Engineering Handbook

SURFACE EQUIPMENT (EHB-8)

MODIFICATION INDEX - CLOUD MEASURING EQUIPMENT

CLOUD HEIGHT MEASUREMENT EQUIPMENT MODIFICATION NO. 21
(For Electronics Technicians)

Fig.1:- Cloud Height Measurement Equipment, Mod. No.2.1.

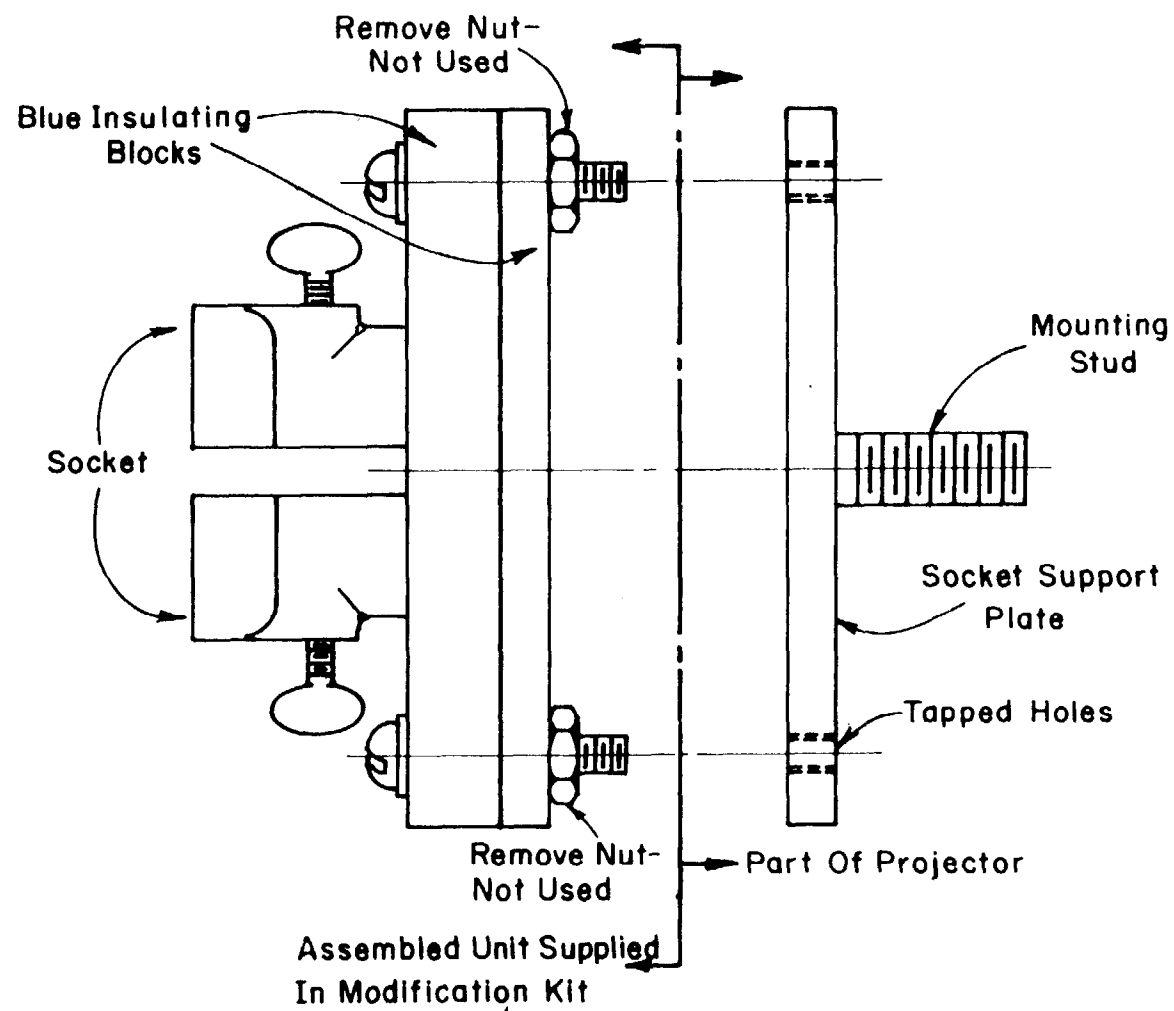
9. Remove the two nuts (indicated in Fig. 1), from the assembled medium bi-post socket assembly and install in place of the old socket.
10. Insert lamp adapter. This is the same adapter as used in the RBC Projector with the outer shield removed. NOTE: In case a new adapter is required, it should be ordered by stores requisition from the CLSC using Stock No. K210-E319. When received, dismantle and remove outer shield.

Figure 1 - SCHEMATIC WIRING DIAGRAM

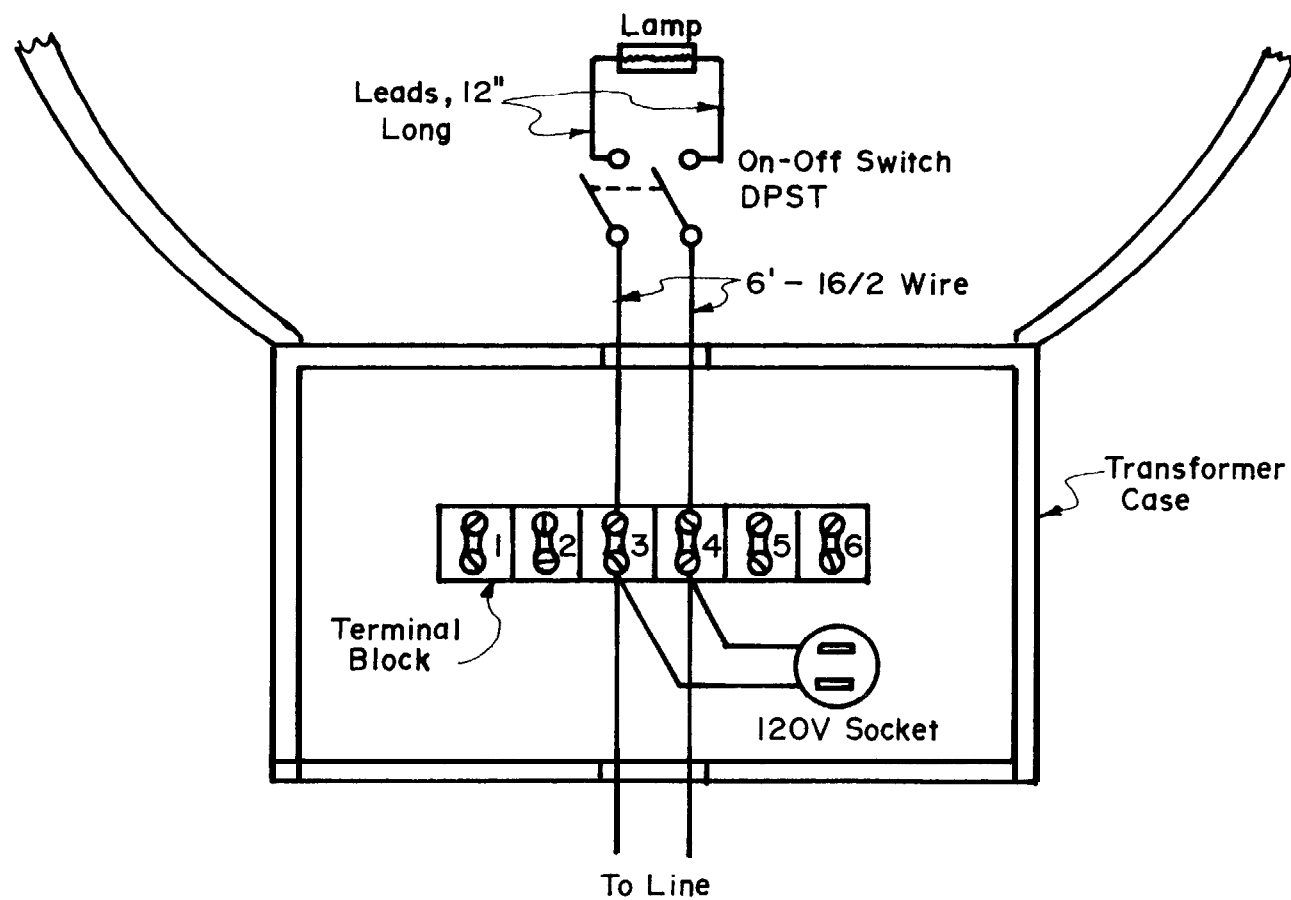
17. Assemble the lamp assembly and install as shown in the drawing. Connect the two leads from the ON/OFF switch to separate terminals on the medium bi -post base.

Figure 3 - WESTINGHOUSE CEILING LIGHT MODIFICATION
(WITHOUT SADDLE)

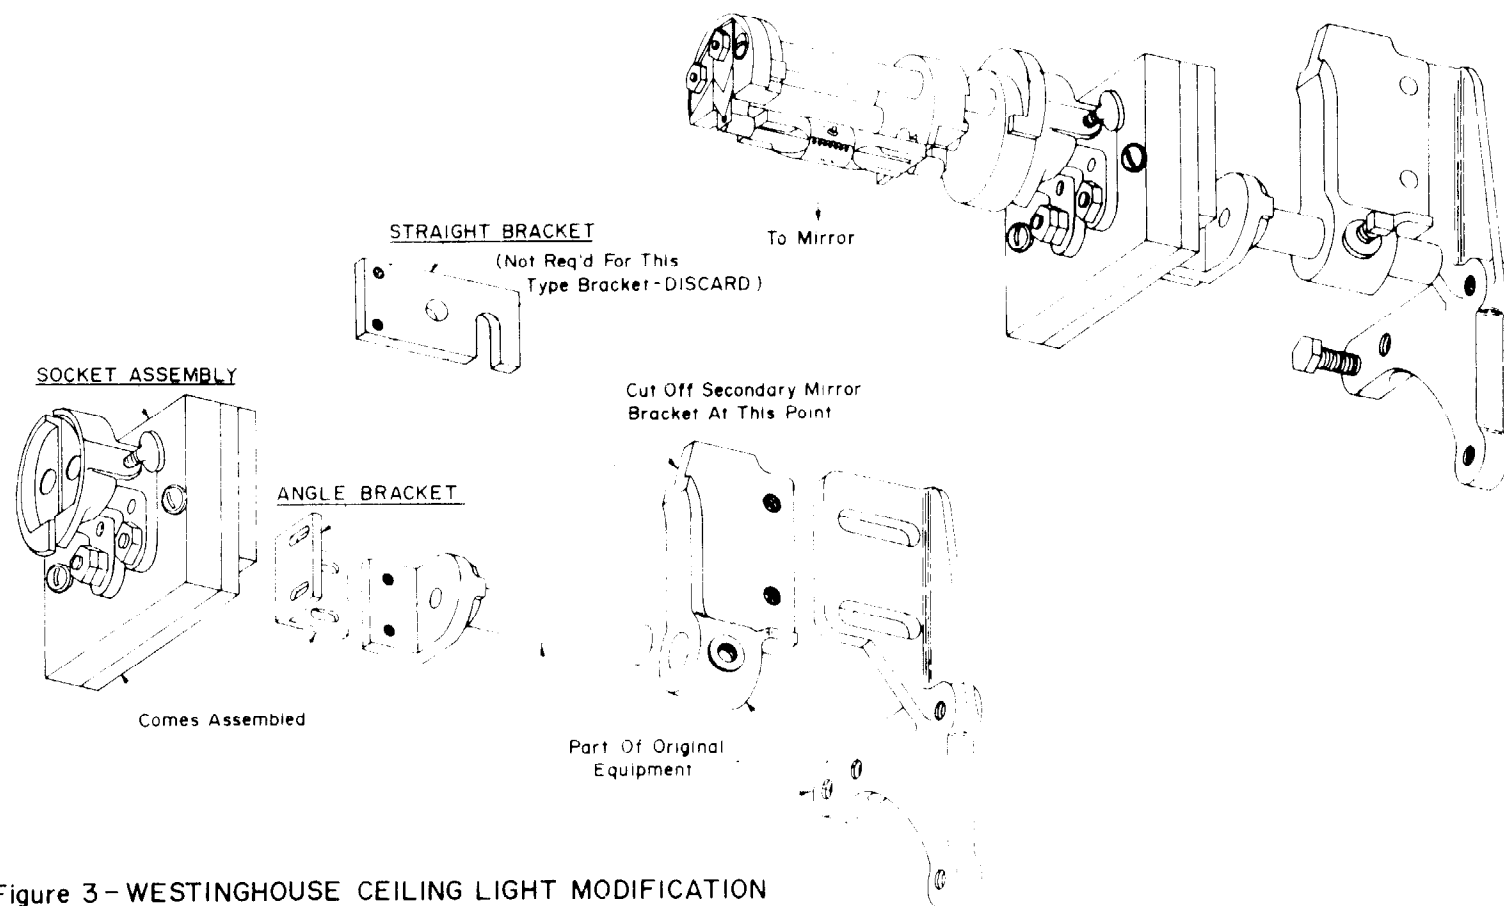
One design, which we will call "A", has the projector drum connected directly to the transformer mounting case assembly. The other design, we will call "B", has the projector drum resting in a "U" support bracket with the transformer case bolted to the "U" bracket. The lamp mounting brackets are referred to as "Saddle" (Figure 4), and "Without Saddle" (Figure 3) type. The attached drawings show the differences and must be adhered to when performing this modification.

drawing. The "Saddle" type does not require any cutting.

FIGURE - 2

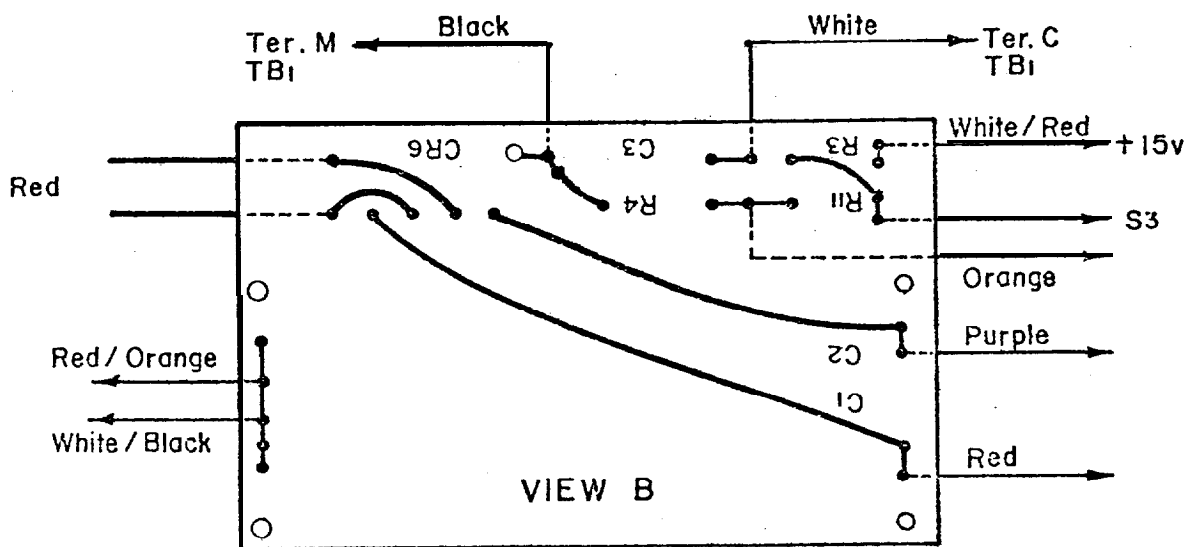
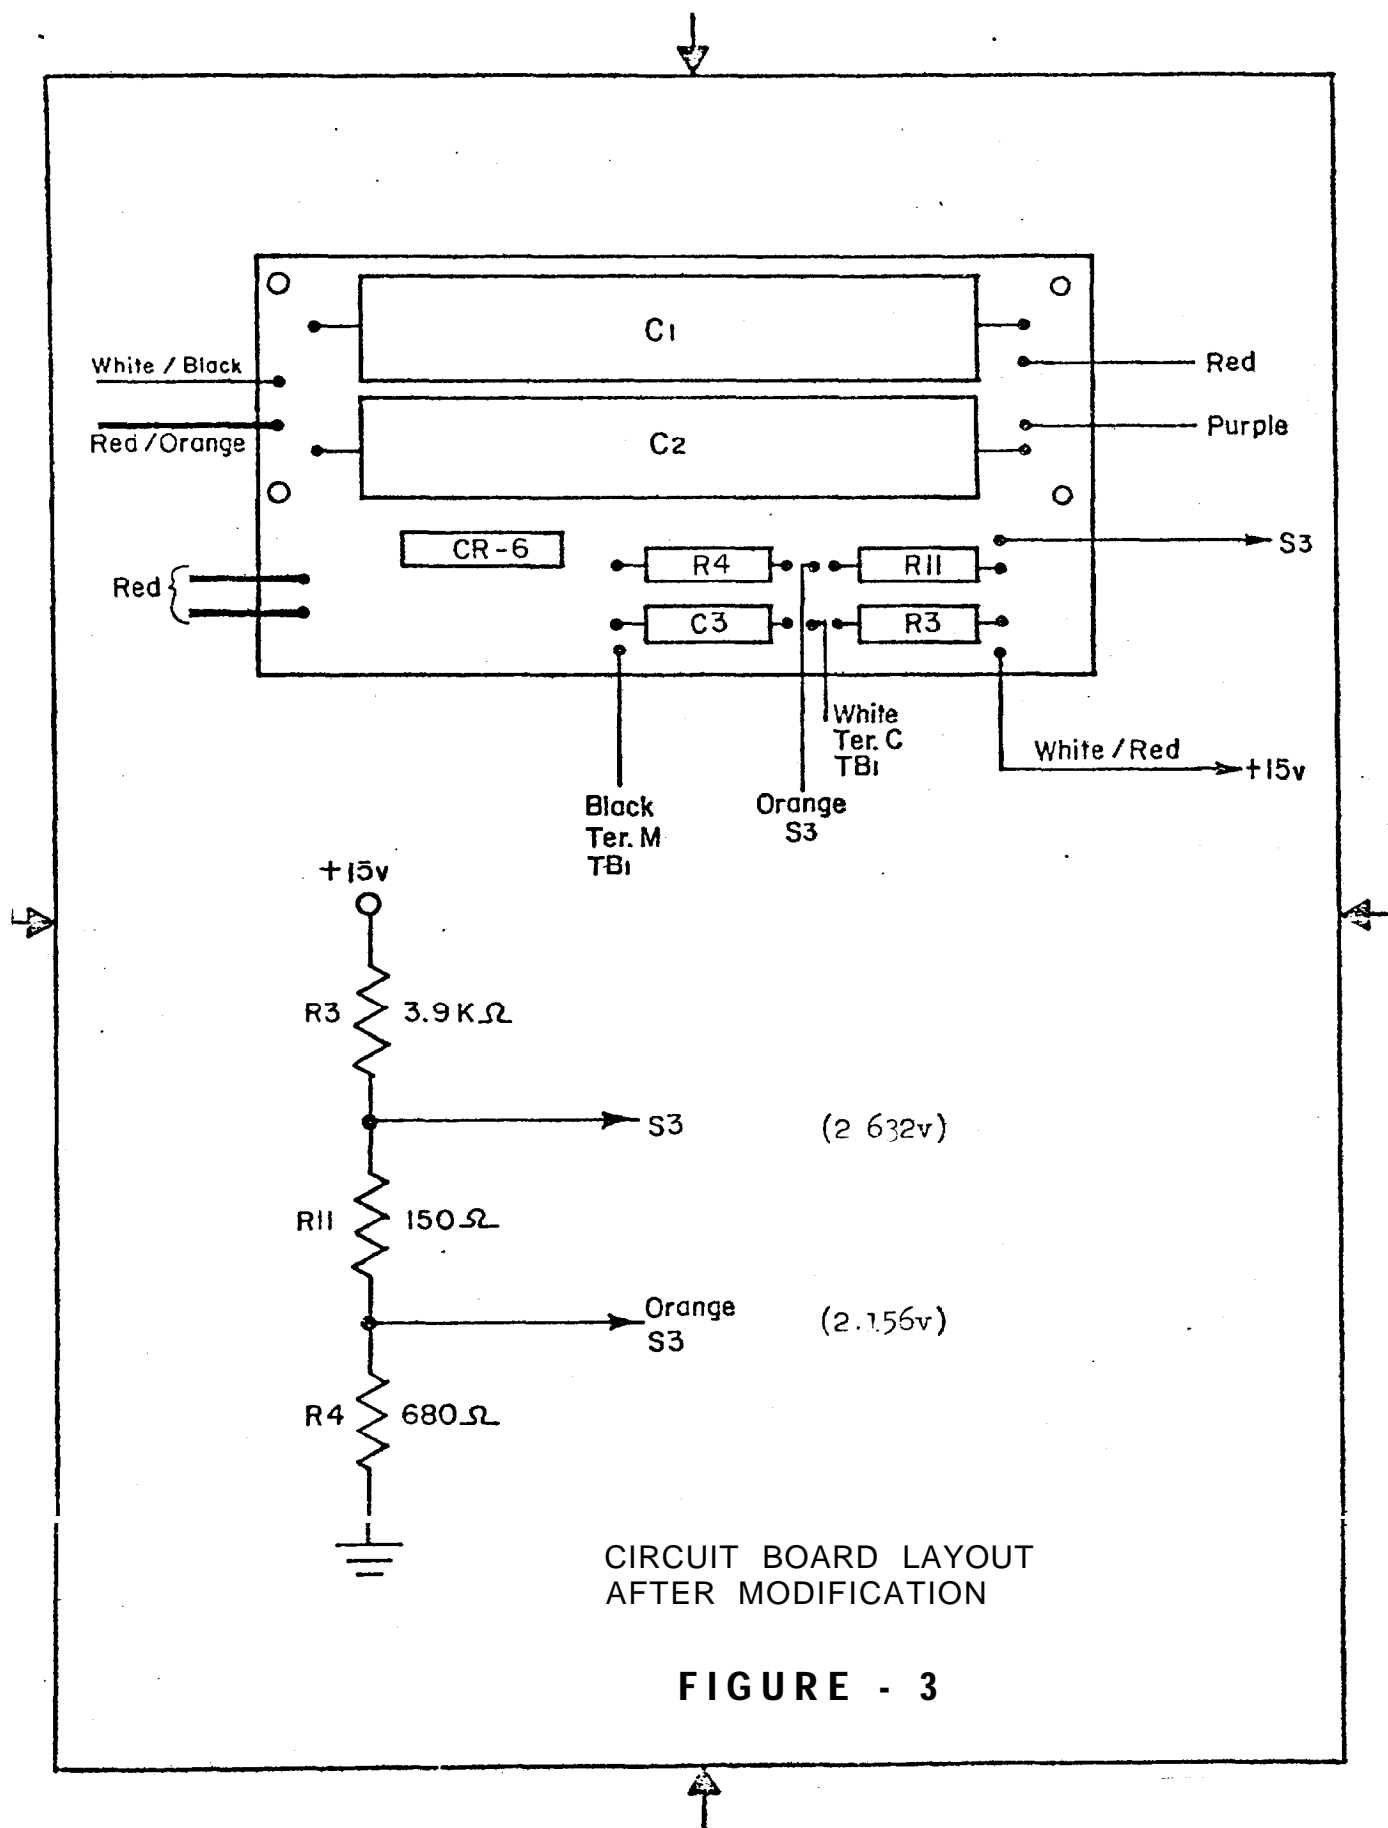
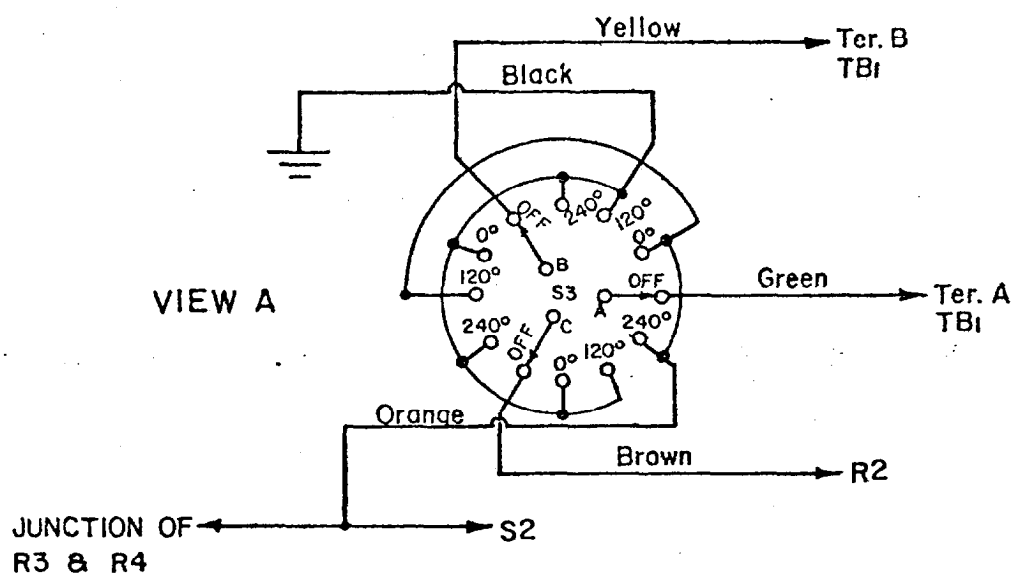
2. With the appropriate hand tools, remove the BROWN wire which connects to R2 and solder it (along with the WHITE wire) to Terminal C on TB-1.
3. Carefully remove the present Resistors R2, R3, R4, and the WHITE/RED wire from the printed circuit board. Save R2 for later use in this modification. These resistors may be located by viewing Figure 2, View A.

4. Solder the WHITE/RED wire to the land area from which the BROWN wire was removed at R2 in Step 2. (See Figure 2, Views A and B for precise locations.)

5. After removal of the resistors, locate the triple land area junction points of C3 (the WHITE wire which goes to Terminal C on TB-1) and the land area from which R2 was removed. This is the top triple land area on the right side of the printed circuit board as seen in Figure 2, View A.

8. Install the resistors contained in the modification kit as shown in Figure 2, View B. Insert one lead of R3 through the hole left vacant due to the WHITE/RED wire being removed in Step 3. Make certain the R3 lead is long enough to reach through the hole.

FIGURE - 4

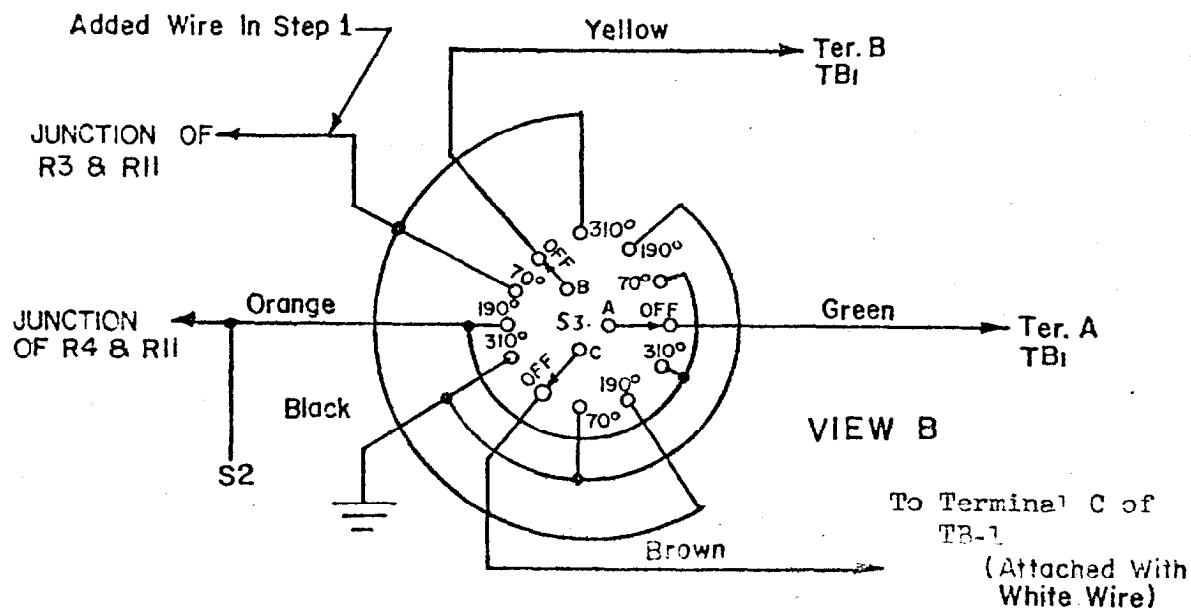
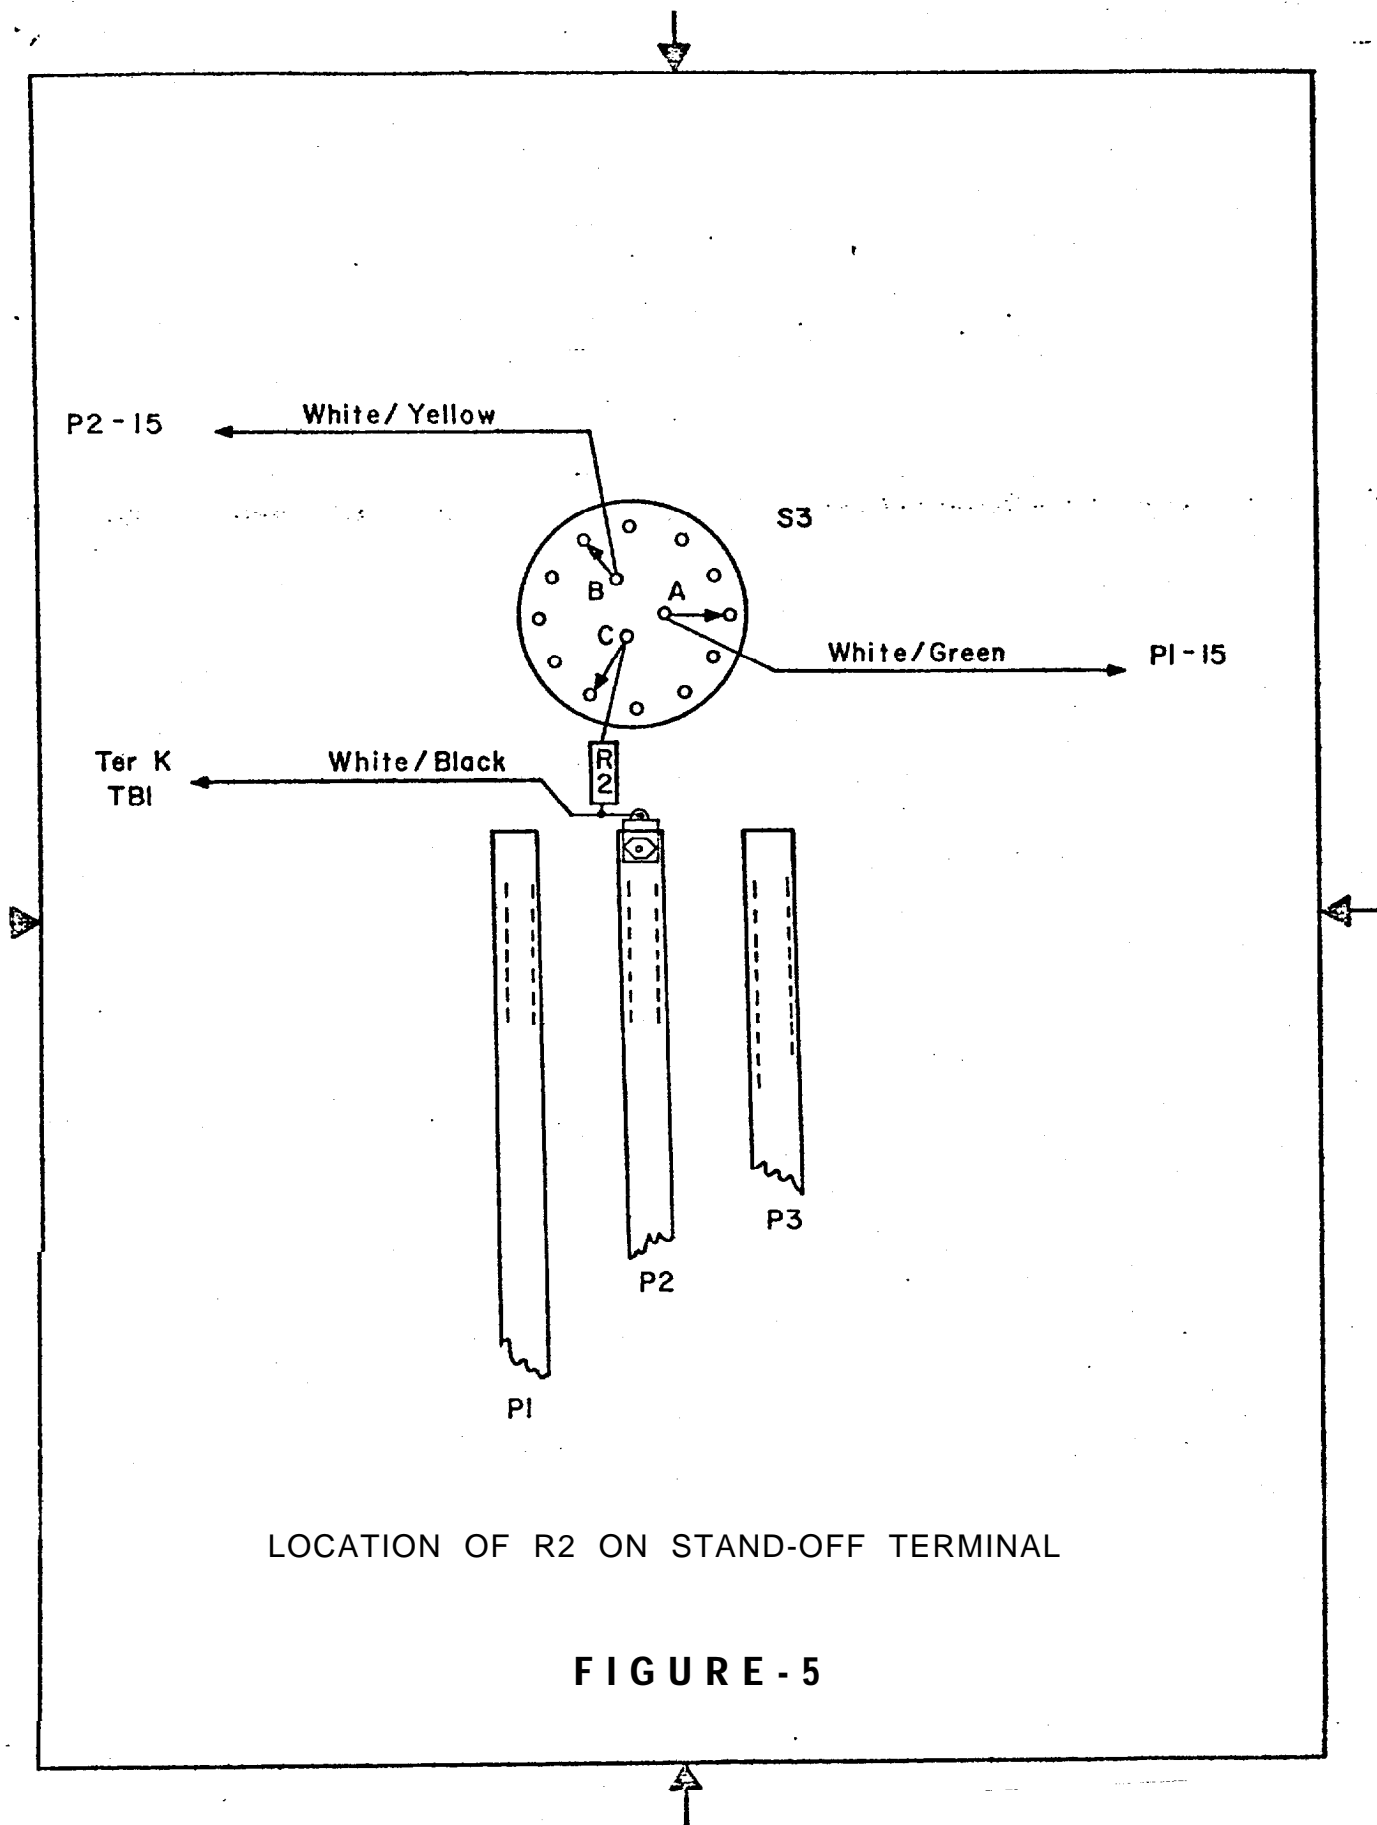
10. Replace printed circuit board in retransmitter and secure it with the four screws to the chassis.
11. Remove knob and nut that secures direction switch S. Position switch so the inner three terminals can be viewed. Refer to Figure 4, View A, and Figure 5 to locate the switch sections A, B, and C.

12. Unsolder the ORANGE, BLACK, AND WHITE/BLACK wires from switch S3.
13. Unsolder and remove the BLACK strap wires from around switch. Refer to Figure 4, View A.

14. Rewire switch S3 with new strap wires as shown in Figure 4, View B. Be sure to insulate these new strap wires with sleeving (spaghetti).
15. Resolder the ORANGE and BLACK wires that were disconnected in Step 12, as shown in Figure 4, View B.

16. Route the hook-up wire that was attached to the junction of R3 and R11, in Step 9, along the wire bundle. Solder it to switch S3 as shown in Figure 4, View B.
